April 11, 2011
U7-C-NINA-NRC-110059

South Texas Project
Units 3 and 4
Docket Nos. 52-012 and 52-013
Supplemental Response to Request for Additional Information

RAI 03.07.01-2, Supplement 2**QUESTION:**

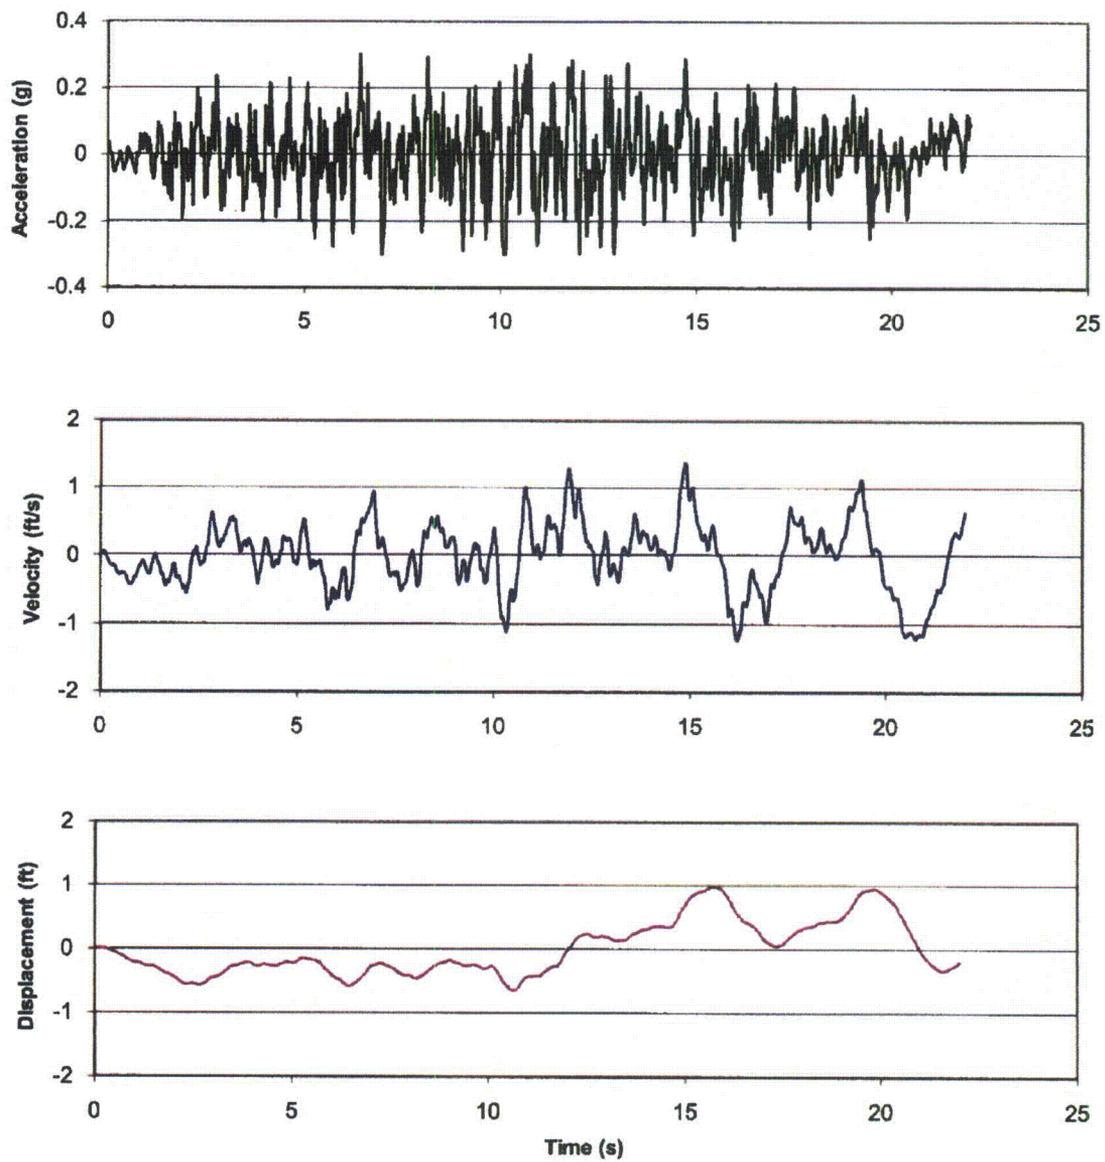
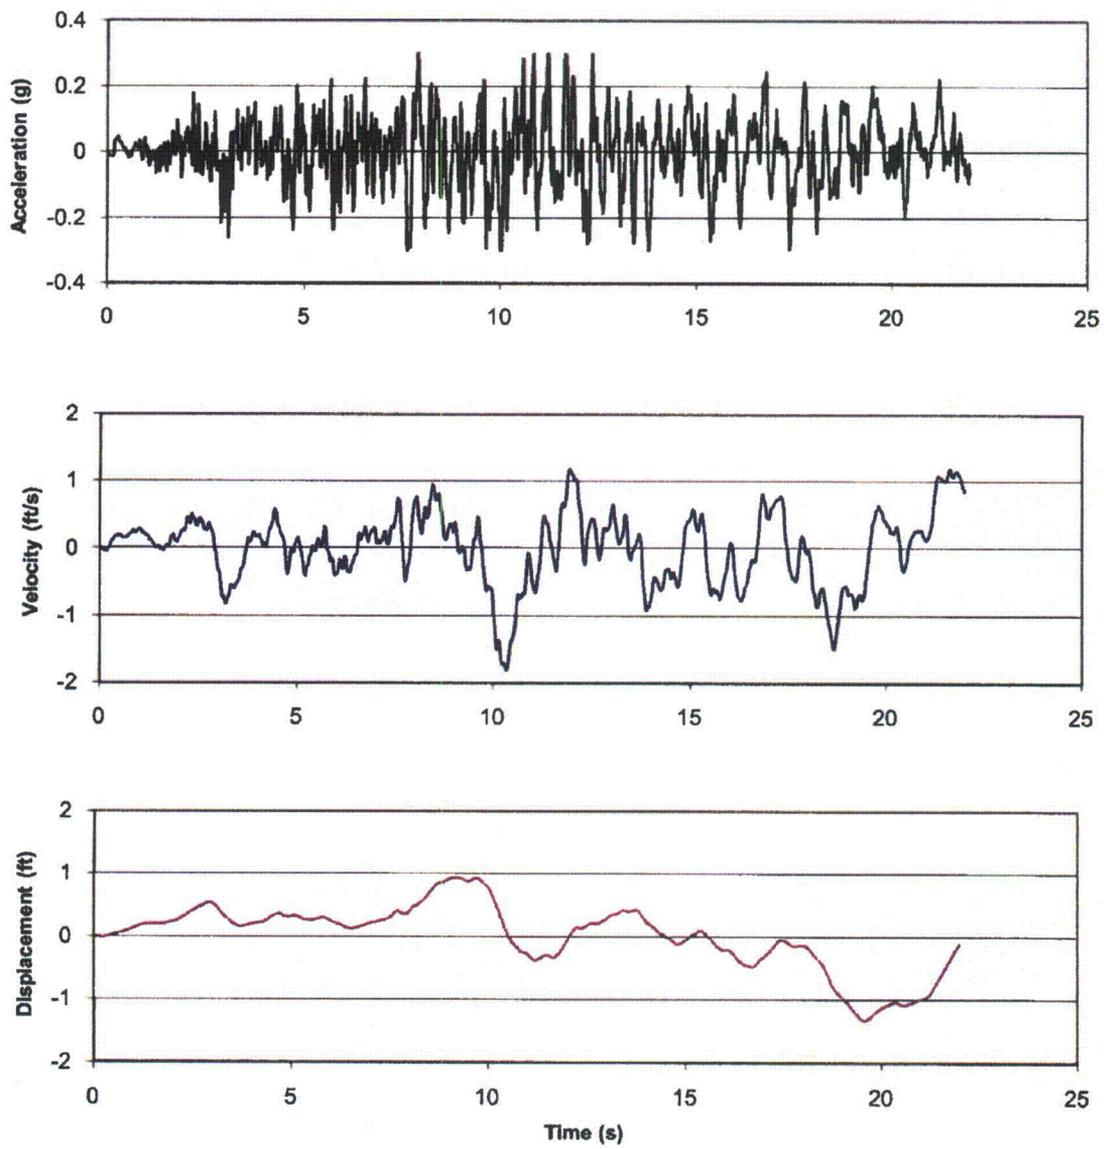
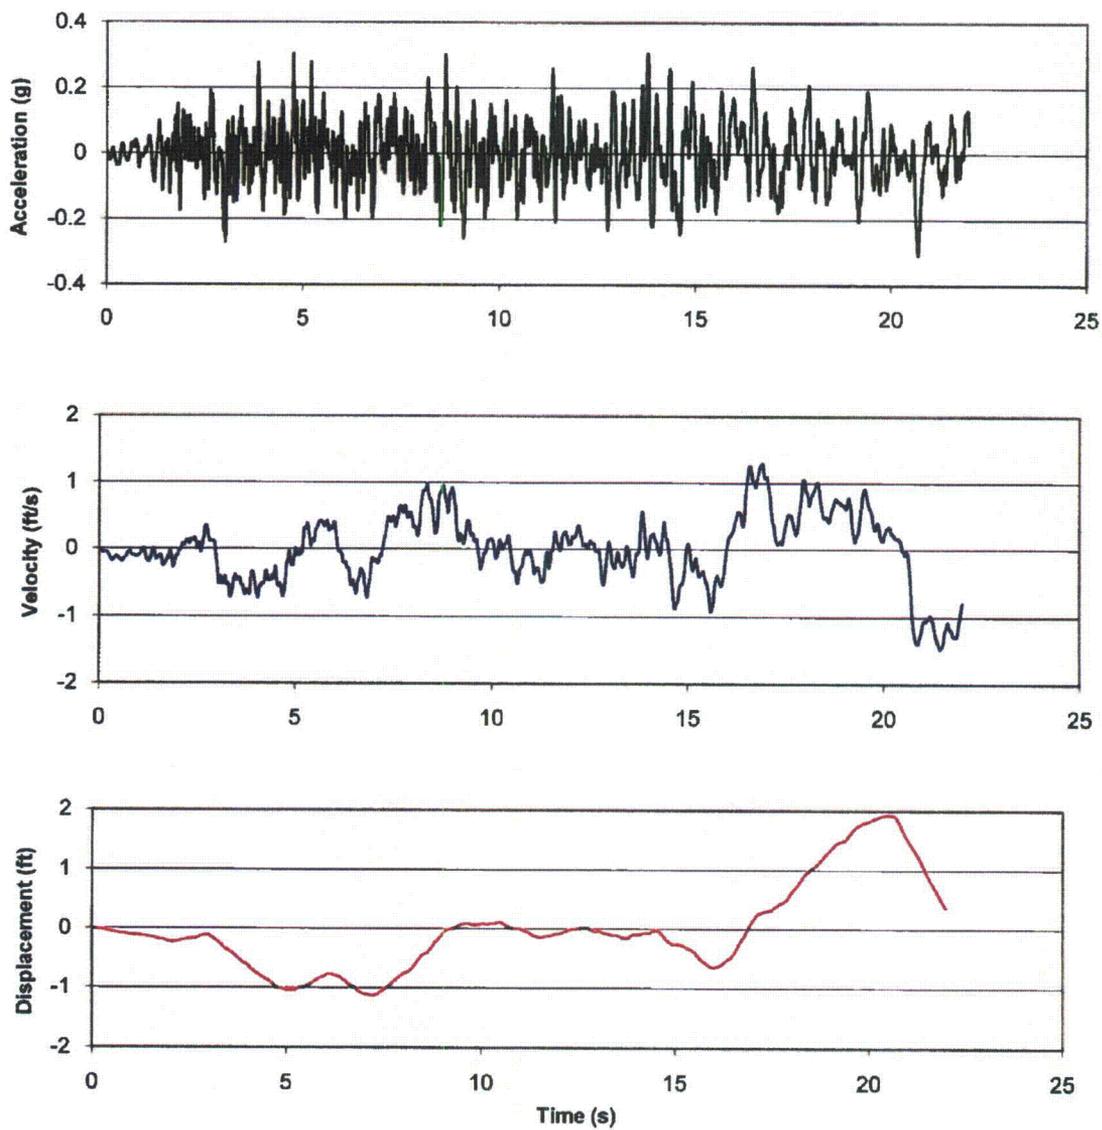
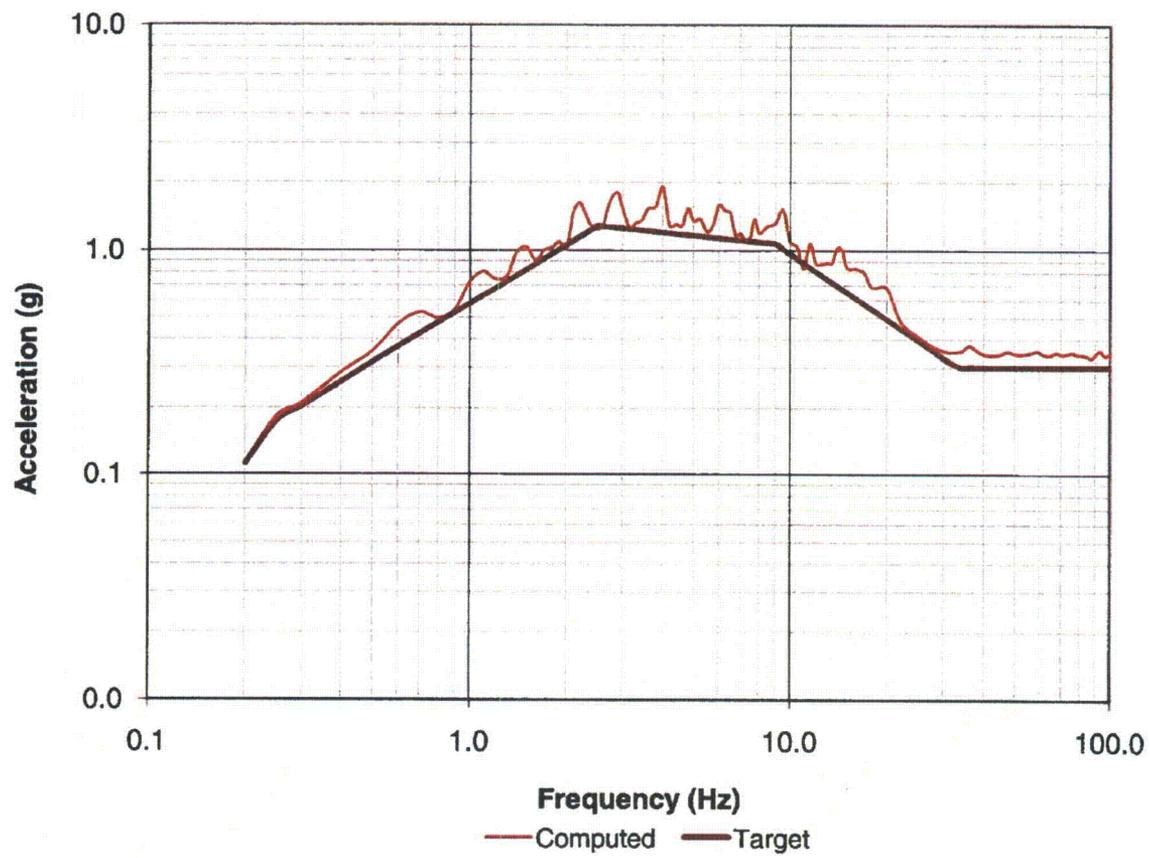
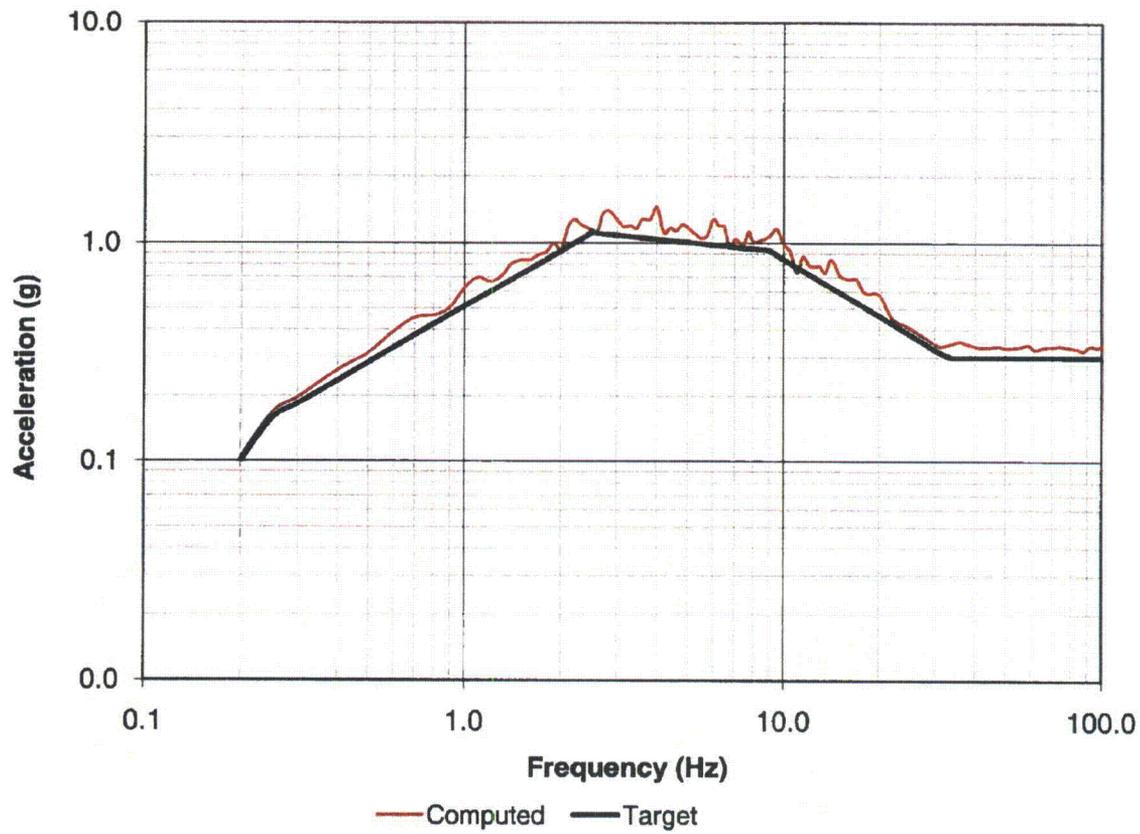
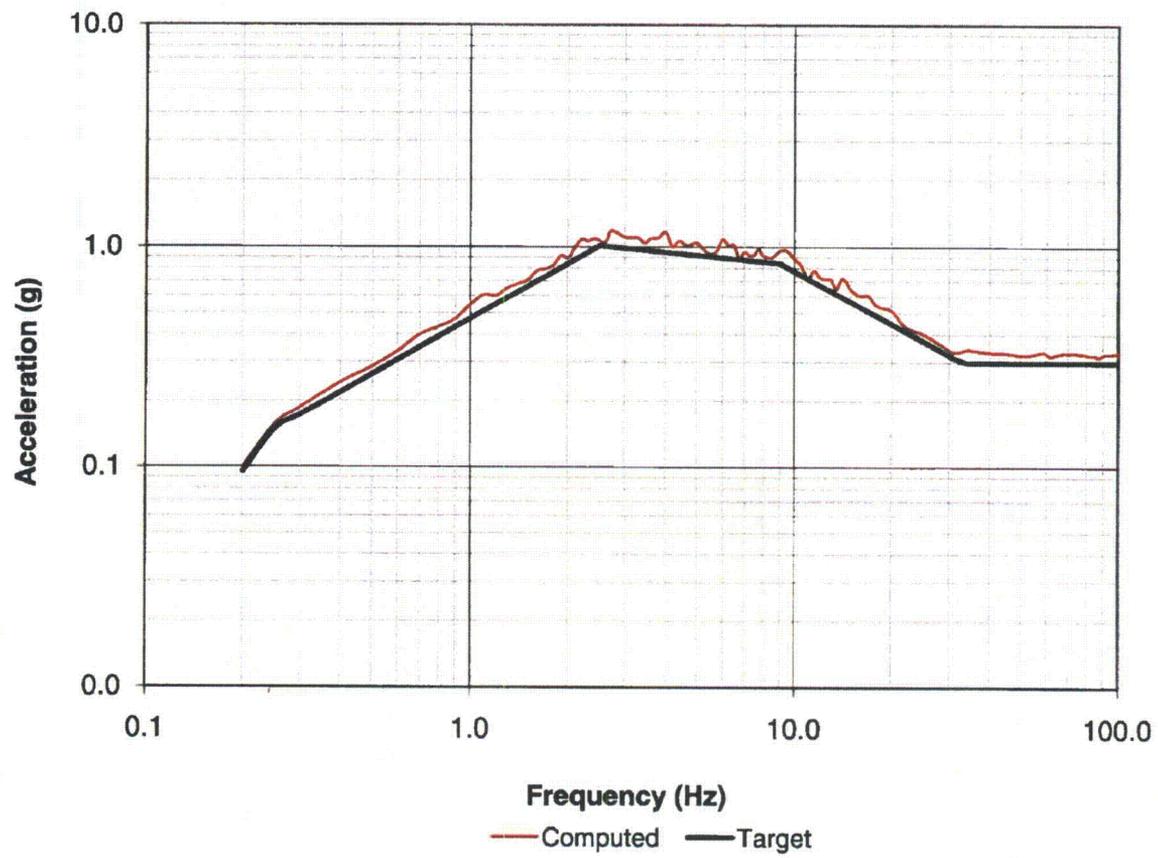
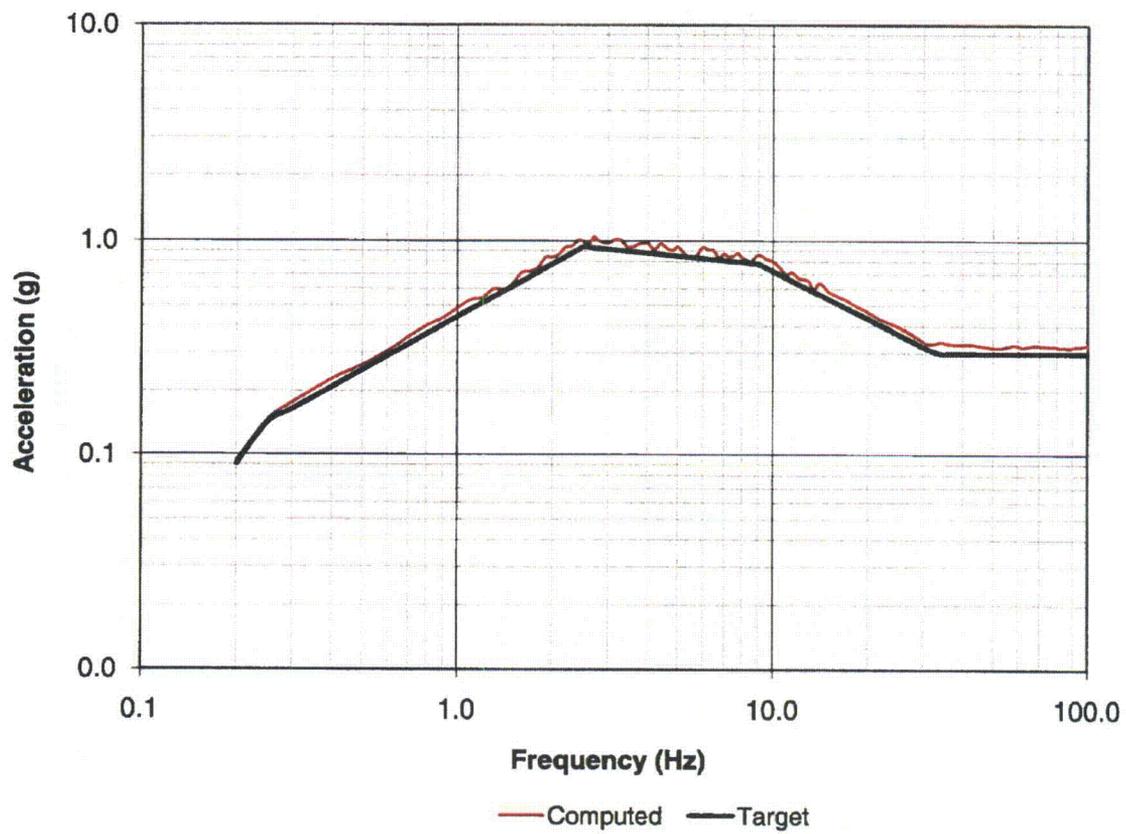
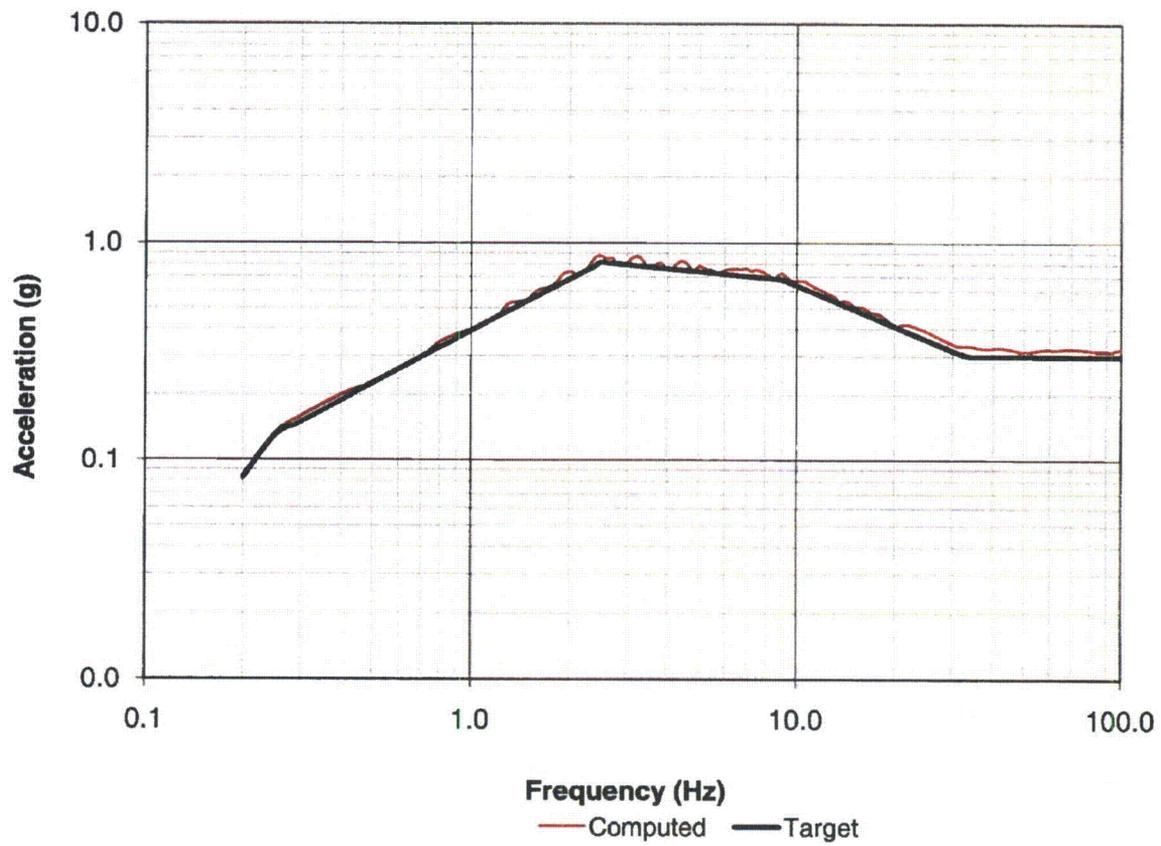
1. Site-specific SSE design response spectra for all applicable damping values (include specific figures) used for seismic reconciliation with the standard plant results as well as for site-specific seismic analysis and design of applicable site-specific structures (Ultimate Heat Sink, and Reactor Service Water (RSW) Piping Tunnel.)
2. Site-specific statistically independent three components of SSE design time histories and their bases that apply for the site-specific analysis.
3. Site-specific Operating Basis Earthquake (OBE) to be used for setting up the seismic instrumentation (FSAR Section 3.7.4).

The original response to this RAI, submitted with letter U7-C-STP-NRC-090105, dated August 20, 2009, provided information on the site-specific Safe Shutdown Earthquake (SSE) time histories. In the seismic analyses performed for the Diesel Generator Fuel Oil Tunnel and Diesel Generator Fuel Oil Storage Vault, consistent time histories for the Certified Seismic Design Response Spectra are required. These time histories were developed and subsequently reviewed during the NRC Audit of March 14-18, 2011. The NRC Staff requested that information on these time histories be added to the COLA to reflect the analysis performed for the Diesel Generator Fuel Oil Tunnel and Diesel Generator Fuel Oil Storage Vault.

The seismic analysis of the Diesel Generator Fuel Oil Storage Vaults and Diesel Generator Fuel Oil Tunnels use the SSE ground motion included in Tier 1 Table 5.0, in addition to the site-specific SSE ground motion, as described in Sections 3H.6.7 and 3H.7, respectively. Since the DCD does not include the digitized information for the SSE time histories, new time histories consistent with Regulatory Guide 1.60 response spectra anchored to peak ground acceleration of 0.3g were developed for use in these analyses. Acceleration time history records obtained from 1994 Northridge Earthquake were used as seed time histories in generating these synthetic time histories. The time histories were developed in accordance with the criteria described in Section 3.7.1.2, using computer programs SYNQKE-R, HIST, and QUAKE described in Appendix 3C.

The plots of the acceleration, velocity, and displacement time histories of the two horizontal and the vertical components are shown in Figures 3H.8-1 through 3H.8-3. The plots of response spectra for 2%, 3%, 4%, 5%, and 7% damping, showing the comparison of the target response spectra (Regulatory Guide 1.60 spectra) with the spectra of the synthetic time histories, are shown in Figures 3H.8-4 through 3H.8-18. The plots of power spectral density functions (PSD) showing the comparison of the target PSD, corresponding to the Regulatory Guide 1.60 spectra, with the PSD of the synthetic time histories are shown in Figures 3H.8-19 through 3H.8-21.
